Serial: BSEP 17-0116

Subject: Brunswick Steam Electric Plant, Unit Nos. 1 and 2
Renewed Facility Operating License Nos. DPR-71 and DPR-62
Docket Nos. 50-325 and 50-324
Response to Request for Additional Information Regarding Request for Risk-Informed Exigent License Amendment - Technical Specification 3.8.1, *AC Sources – Operating, One-Time Extension of Emergency Diesel Generator Completion Times and Suspension of Surveillance Requirements*

Response to Request for Additional Information

Figure 1

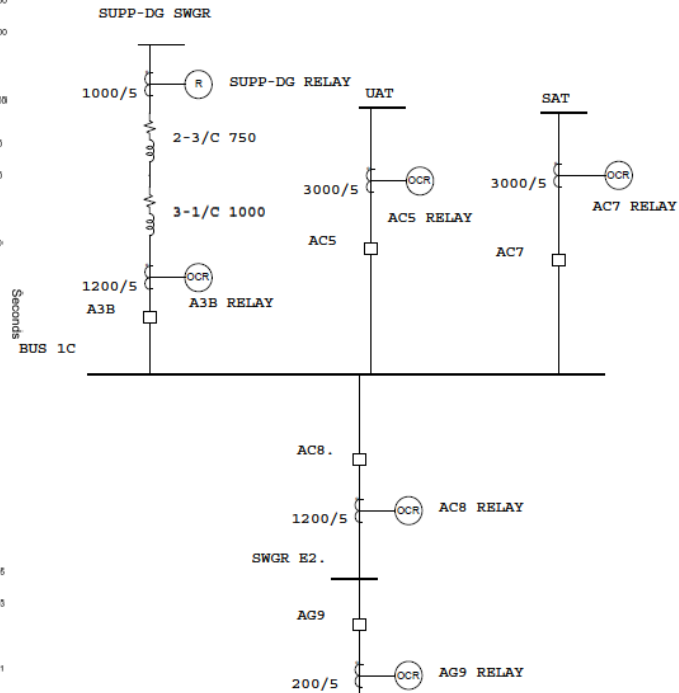
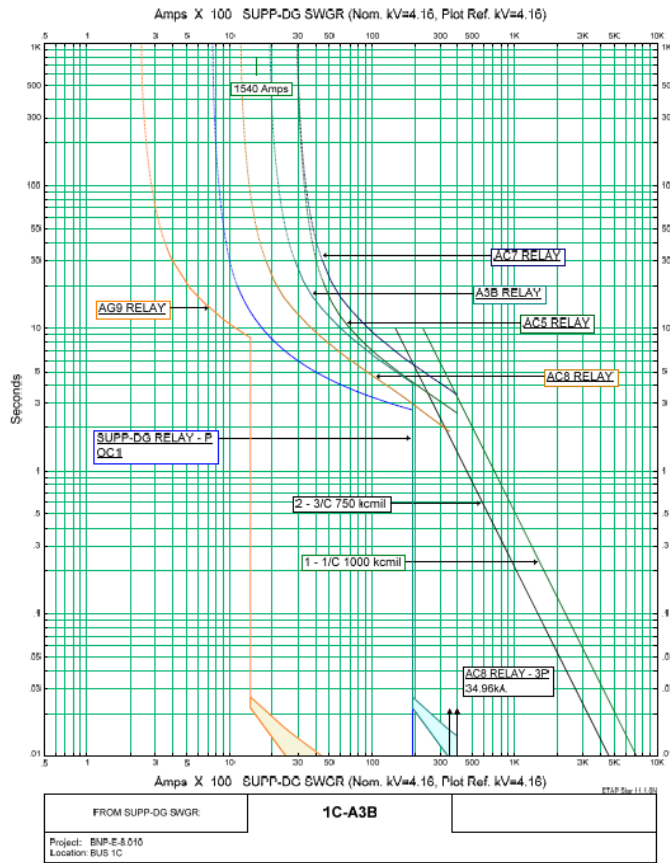
- (b) Please provide a discussion to confirm that the protection devices (breaker/relay etc.) associated with SUPP-DG have been coordinated with the downstream protection devices.

The coordination, as documented in EC 279694 Attachment B.5.13, provides protection for the SUPP-DG. Other devices' protection schemes are coordinated to protect the buses. From EC 279694, Attachment B.5.13:

The over-current protection (50/51V) of the 700G relay has been set to protect the cable as shown on Figure 1. As shown on Figure 1, when the SUPP-DG is feeding an emergency bus, a fault on the emergency bus will actuate the 700G over-current protection before the fault is cleared by the emergency bus over-current protection, which is not selective coordination (i.e., protective device closest to the fault will actuate first). If the emergency bus being fed by the SUPP-DG is not available due to a fault, then the SUPP-DG would no longer be capable of feeding the bus and non-selective tripping of the output breaker is acceptable. Therefore, the relay settings selected will provide adequate coordination and cable protection.

Figure 1 is one of the Time Current Characteristic Curves for the SUPP-DG. In the event of a short circuit exceeding 20 kA, overcurrent relays AG9 and SUPP-DG will trip instantaneously (i.e., with a time delay setting of 0.1 seconds).

The SUPP-DG is rated at 4,000 kW and its short circuit current is 5.5 kA (i.e., Full Load Amps / subtransient reactance). If a fault is greater than 5.5 kA, but less than 20 kA for approximately 4+ seconds, the SUPP-DG relay will trip to protect itself if the AG9 relay has not tripped at a lower value.
